SUBDIVISION REVIEW SHEET**CASE NO.:** C8-2016-0247.1A**P.C. DATE:** September 8, 2020**SUBDIVISION NAME:** Pioneer Crossing East Section 19 Final Plat**AREA:** 7.15 acres**LOTS:** 32**APPLICANT:** Continental Homes of Texas, LP
(Kevin Pape)**AGENT:** LJA Engineering, Inc.
(Justin D. Midura, P.E.)**ADDRESS OF SUBDIVISION:** Samsung Blvd. & 200-751 E. Braker Lane**WATERSHED:** Walnut Creek**COUNTY:** Travis**EXISTING ZONING:** P.U.D**JURISDICTION:** Full Purpose**PROPOSED LAND USE:** Residential**VARIANCE:** none**DEPARTMENT COMMENTS:**

The request is for the approval of Pioneer Crossing East Section 19 Final Plat, comprised of 32 lots on 7.15 acres.

CITY OF AUSTIN –DEVELOPMENT SERVICES DEPARTMENT
SUBDIVISION APPLICATION – MASTER COMMENT REPORT

PROJECT NAME: Pioneer Crossing East Section 19 Final Plat
LOCATION: 200-751 E BRAKER LN

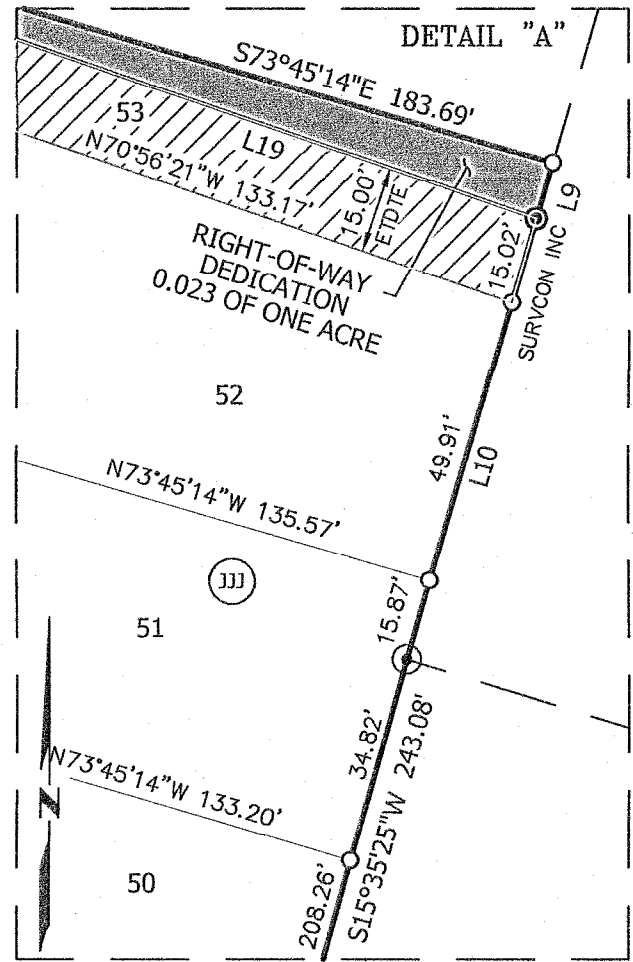
EL 1. U1: **Comment stands.** Internal drives should have 10' electric distribution, electric telecommunications, and electric fiber easement instead of PUE. Though Andy Halm has worked with you to come up with solutions for other projects, it is not applicable to all projects. If you have any questions, please email him at Andrew.Halm@austinenergy.com

FYI- remove prelim notes on the plat that state not for recordation.

TR2. Per prelim, please show sidewalks by a dotted line along E. Braker Lane. Braker is already included in the final plat note.

U1: Comment remains. Please update dotted line to include the development side of Samsung Way.

COMMENT NOT FULLY ADDRESSED. THERE ARE EXISTING WASTEWATER EASEMENTS SHOWN ON THE PLAT.

AW1. Per Utility Criteria Manual Section 2, §15-9, §25-4, and §25-5:
THE WATER AND/OR WASTEWATER EASEMENTS INDICATED ON THIS PLAT ARE FOR THE PURPOSE OF CONSTRUCTION, OPERATION, MAINTENANCE, REPAIR, REPLACEMENT, UPGRADE, DECOMMISSIONING AND REMOVAL OF WATER AND/OR WASTEWATER FACILITIES AND APPURTENANCES. NO OBJECTS, INCLUDING BUT NOT LIMITED TO, BUILDINGS, RETAINING WALLS, TREES OR OTHER STRUCTURES ARE PERMITTED IN WATER AND/OR WASTEWATER EASEMENTS EXCEPT AS APPROVED BY AUSTIN WATER.
